Addendum 148 – UN Regulation No. 149

Amendment 3

Supplement 3 to the original version of the Regulation – Date of entry into force:
30 September 2021

Uniform provisions concerning the approval of road illumination devices (lamps) and systems for power-driven vehicles

"Figure A4-IX

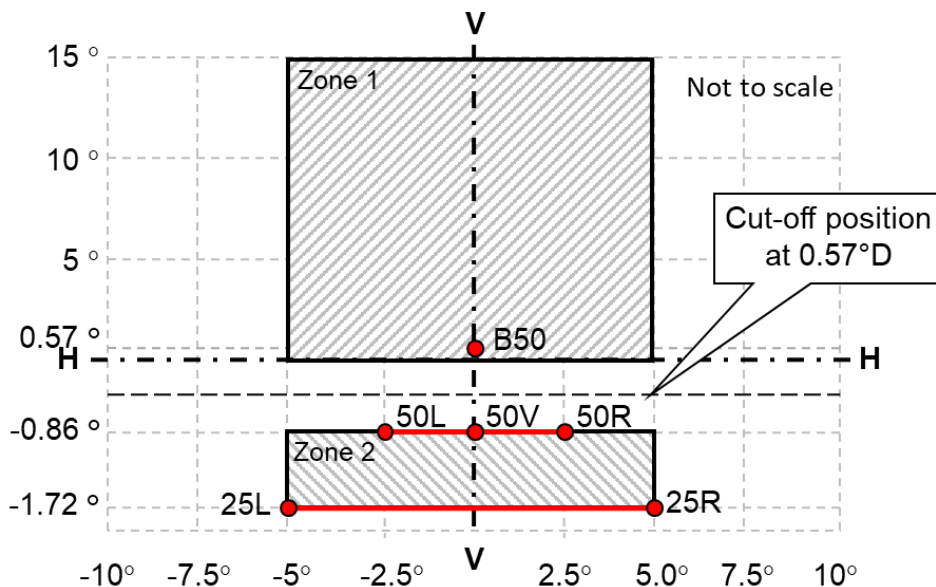
Figure A4-IX; amend to read:

Passing beam test points and zones for Class BS headlamp(s)

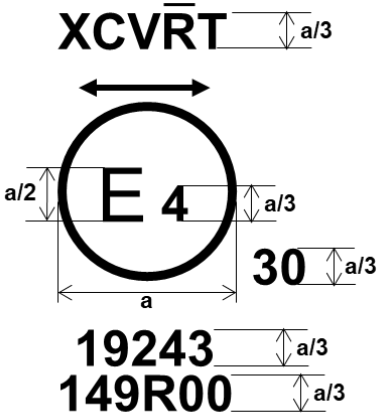
Paragraph 2.1.2.2.1. (a) and (b), amend to read:

(b) Passing-beam, for AFS system:

Class C passing beam and each specified other passing beam class:

50V, B50L and 25LL, if applicable"

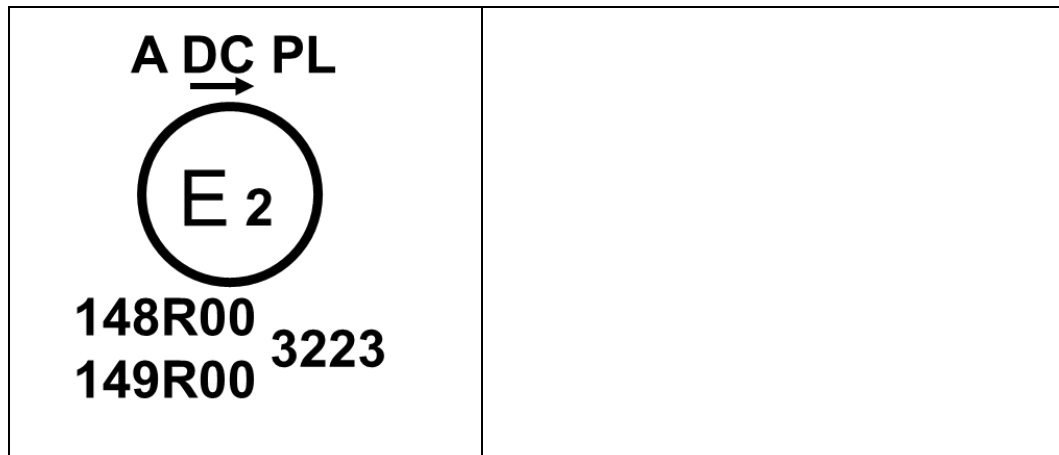
Annex 13, amend to read:

<p>Figure A13-I - Marking example 1</p>  <p>a = see para. 3.3.1.2.1. of this Regulation</p>	<p>The device bearing the approval mark shown on the left is an installation unit of an AFS approved in the Netherlands (E4) under approval number 19243 pursuant to this Regulation.</p> <p>The number after 149R indicates that approval was granted in accordance with the requirements of this Regulation in its original form (00).</p> <p>The functions identification symbols show that the approval was granted in respect of the driving-beam (R) and the Class C and Class V passing-beam. The double pointed arrow shows that the passing beam is suitable for both traffic systems by means of an appropriate adjustment of the setting of the optical element or the light source on the vehicle. Class C passing-beam, Class V passing-beam and driving-beam comply to bending lighting provisions, as indicated by the letter "T". The score above the letter "R" indicates that the driving-beam function is provided by more than one installation unit on that side of the system.</p> <p>Number 30 indicates that the maximum luminous intensity of the driving-beam is between 123,625 and 145,125 candelas.</p>

<p>Figure A13-II - Marking example 2</p>	<p>The lamp bearing the approval mark shown on the left is a gas-discharge passing beam headlamp (DC) for left-hand traffic only (arrow) using a plastic lens (PL) approved in France (E2) pursuant to this Regulation 149R as set in the original series of amendments (00) combined with a front position lamp (A) as set in the original series of amendments (00) of the Regulation on Light Signalling Devices 148R. Both lamps (functions) are approved under approval number 3223.</p>
